## Product Change Notification

**1. ECR #:** 169112  
**Notification #:** 412

**3. Series:**  
• TFM - .050 X .050 MICRO STRIPS

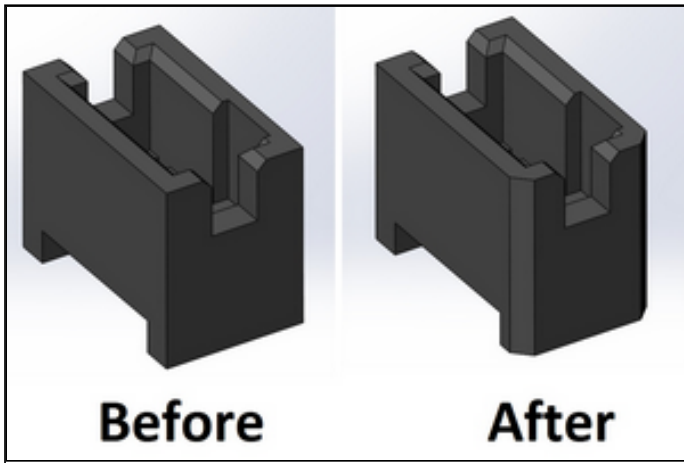
**5. Description of Change:**  
Form change: Chamfers were added to the edge of the plastic insulator body to polarize orientation within tape & reel.

**6. Method of Identifying Change**  
Visual: Chamfers are visible with unaided eye

**8. Impact of Change on Form, Fit, or Function:**  
• Form - Added chamfers are visible under 10X magnification

**7. Reason for Change:**  
This change is being made by Samtec to ensure parts are correctly oriented within tape and reel packaging. There is no change to fit or function of the finished good.
